Lanesborough Road.
Site Development Guidance (SDG)

Report of the Director of Environment & Development.

Lanesborough Road.
Site Development Guidance (SDG)

SUPPORTING INFORMATION

Plan 2 Lanesborough Road Site Planning and Urban Design Layout

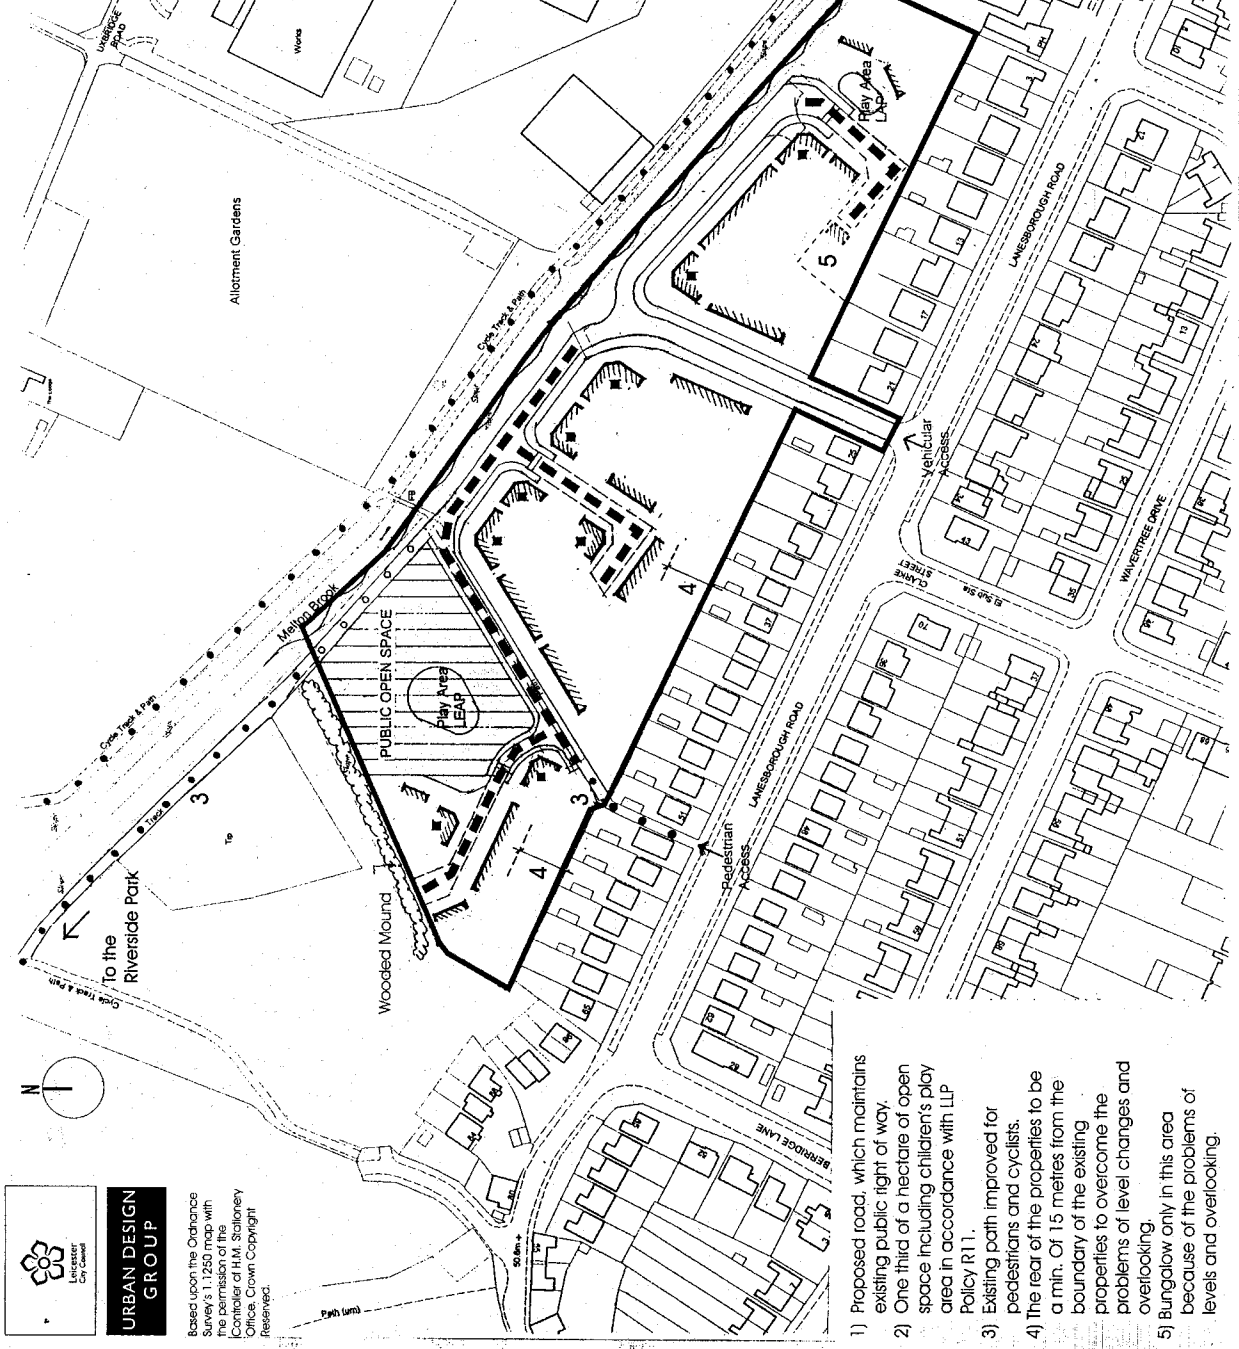
Privacy. There is a comment "that a distance of 15 metres from the rear of houses in the new development to the established rear fences is too tight." The minimum distance required by the Local Plan Appendix 5 is 11 metres but the SDG recommends 15 metres because of raised levels on the site. The SDG design layout has been amended in response to a comment from a resident affected where this distance was indicated closer than 15 metres.

- 1) Proposed road, which maintains existing public right of way.
- 2) One third of a hectare of open space including children's play area in accordance with LLP Policy P11.
- 3) Existing path improved for pedestrians and cyclists.
- 4) The rear of the properties to be a min. Of 15 metres from the boundary of the existing properties to overcome the problems of level changes and overlooking.
- 5) Bungalow only in this area because of the problems of levels and overlooking.
